VSP - 149
DATE: December 16, 2002 (M)

SUBJECT: Distribution of: Kelly Aerospace Service Bulletin No. A-107A

Bulletin No. A-107A

SUBJECT: Inspection of Fuel Regulator Shutoff Valve as Used With Kelly Aerospace Combustion Heaters, Models B1500-B4500

Figure 1

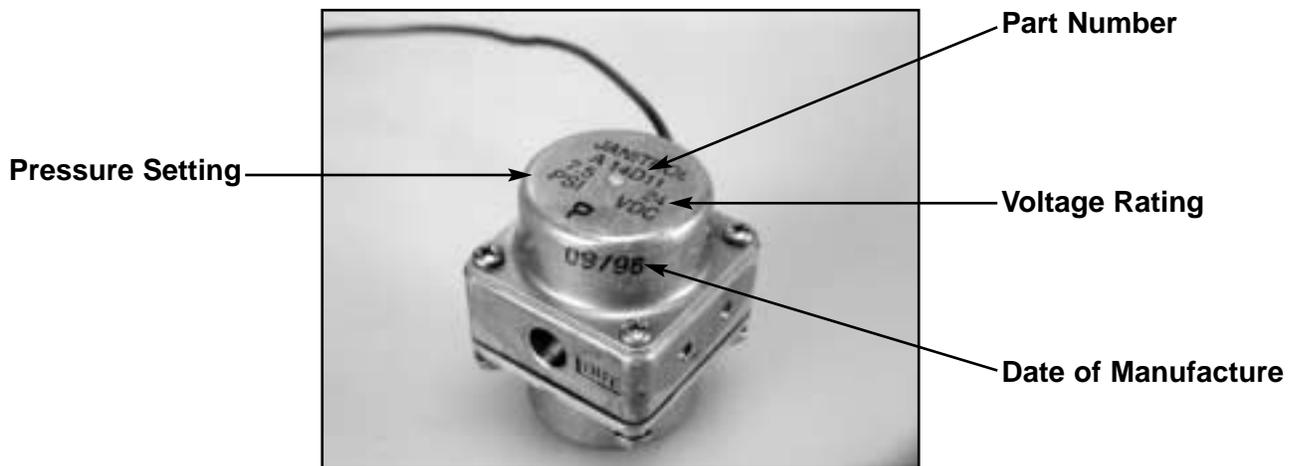
Kelly Aerospace part number 14D11 and 23D04 series fuel regulator and shutoff valves provide positive fuel shutoff and regulation of fuel inlet pressure to Kelly Aerospace model B1500-B4500 series combustion heaters as used on both piston powered and turbine powered business aircraft. These valves operate at inlet pressures of 4-50 psi depending upon installation and regulate fuel outlet pressure (inlet supply to the heater) to 1.0 psi, 7.5 psi, or 12 psi depending upon application. Each valve is identified with part number, pressure setting, voltage rating, and date of manufacture as shown in Figure 1.

- 6) If no signs of fuel stains are found, mark the valve cover with date of inspection (month/year) using permanent ink and letters .12 - .25" high next to or below the date of manufacture. For example, a valve inspected in June 2002 should be marked 06/02. **CAUTION, re-install the valve in accordance with the applicable aircraft maintenance manual exercising care to follow safety precautions.** Record Service Bulletin compliance in the logbook.

Figure 2

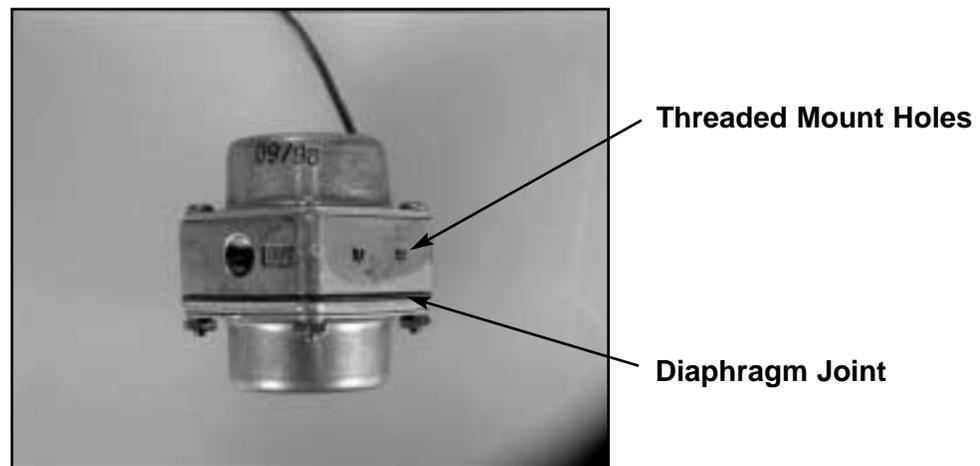
Recent field reports have indicated the possibility of fuel seepage at either the diaphragm joint or threaded mount holes as shown in Figure 2. Within the next 10 hours of operation, inspect the pressure regulator shut off valve for signs of fuel leakage as follows.

- b. Using mineral spirits or JET-A as the test fluid, pressurize the inlet port of the regulator valve to 50 psi for 1 minute minimum with the solenoid energized. Carefully inspect the valve body for signs of fuel leakage giving careful attention to the diaphragm joint and the threaded mount holes as shown in Figure 2. **CAUTION - prior to test, exercise care to wipe valve body and fittings free of any residual fluid that may have contacted external surfaces of the valve during test setup.** Leakage may appear as a wetness or seepage at the diaphragm joint or threaded mount holes. Rotate the valve during pressure test as necessary to fully inspect all external surfaces.

- 5) Visually inspect the valve body for signs of fuel stains, paying careful attention to the diaphragm joint and the threaded mounting holes located in sides of the valve body (see Figure 2). Fuel leakage in those applications using AVGAS may appear as a greenish blue stain or residue in the area of the diaphragm joint or threaded mount hole. Fuel leakage in those applications using JET-A fuel may appear as a wetness or oily residue at the diaphragm joint or threaded mount hole. Utilize supplemental lighting if needed to facilitate visual inspection. Visual inspection must include all four sides of the regulator valve body. If signs of fuel leakage are found replace the valve using a new valve of appropriate part number with a manufacture date code of 02/02 or later. Record valve replacement and Service Bulletin compliance in the logbook.
